2007/2008 INTERNATIONAL RESIDENTIAL BUILDING/ENERGY CODE COMMITTEE

FIGURE R403.3(1)
INSULATION PLACEMENT FOR FROST-PROTECTED FOOTINGS IN HEATED BUILDINGS

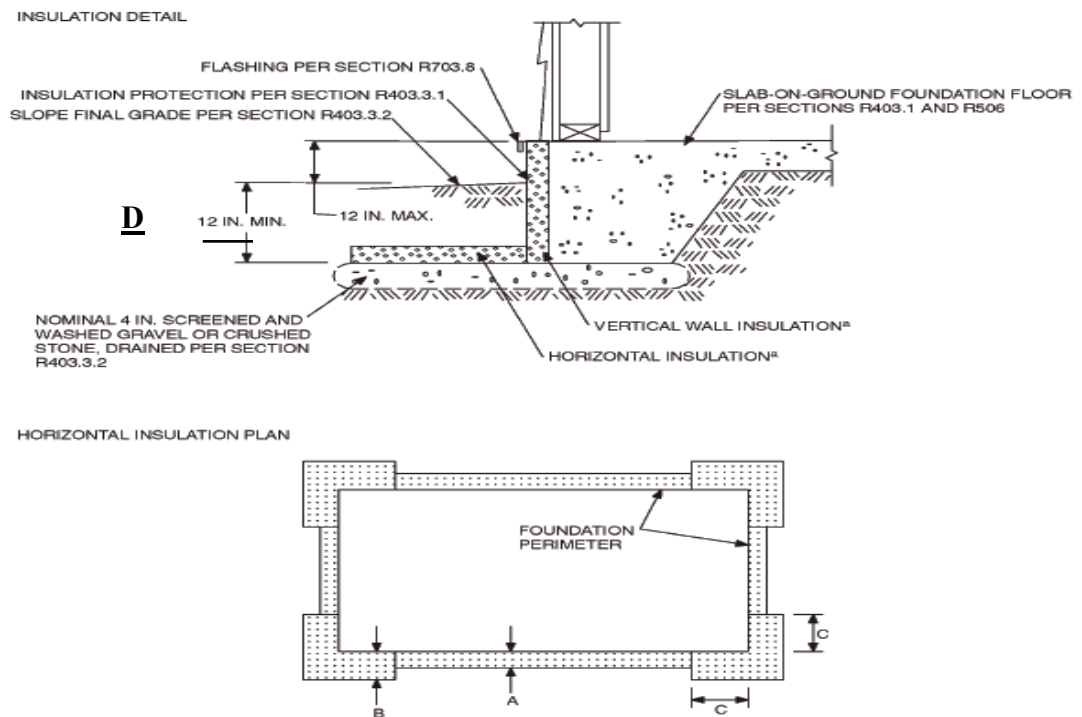
Errata: Move footnote "a" from table and place at bottom of Figure R403.3(1) as shown:

Committee Reason: This change provides a useful clarification to the code and correlates with ASCE 32 as stated in the proponent's published reason.

FIGURE R602.10.5
MASONRY STEM WALLS SUPPORTING BRACED WALL PANELS

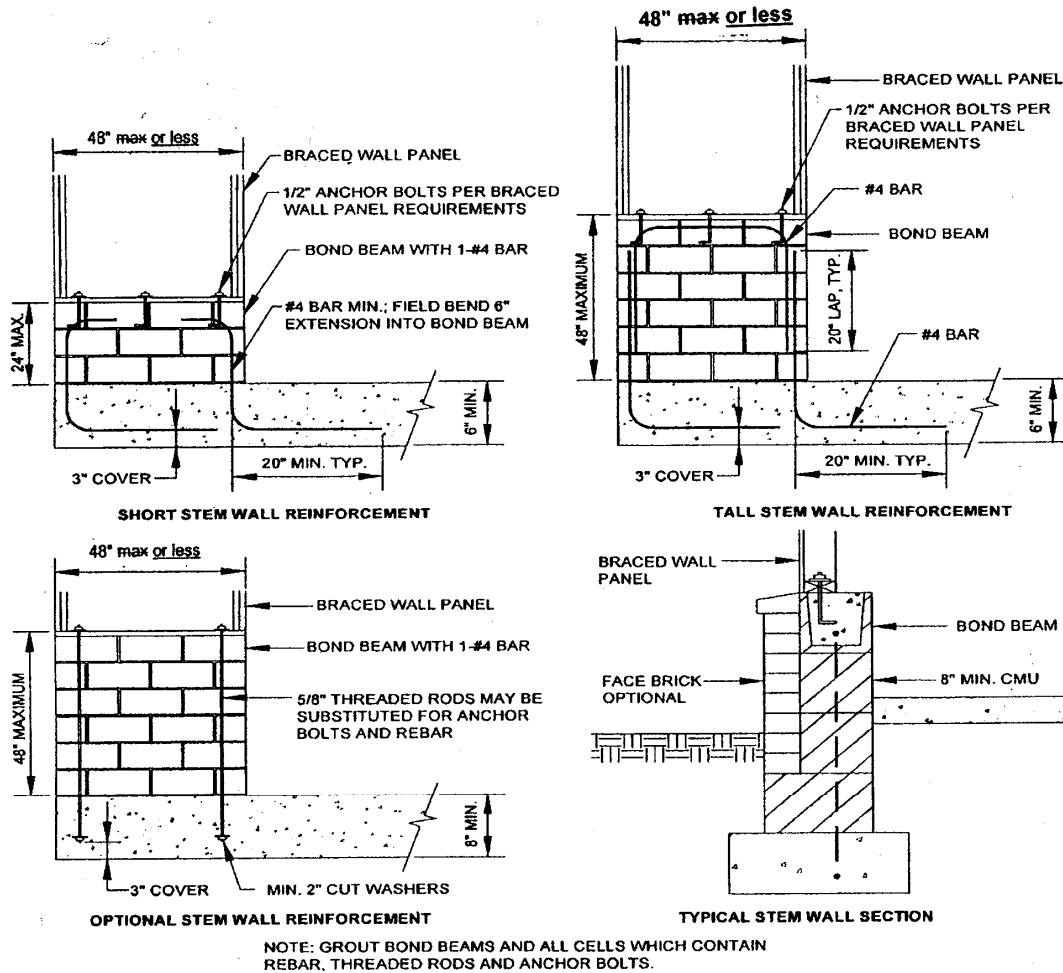
Modify the proposal as follows:

Committee Reason: This change addresses a condition that occurs frequently in residential construction. As stated in the proponent's published reason. The modification clarifies the limiting condition.
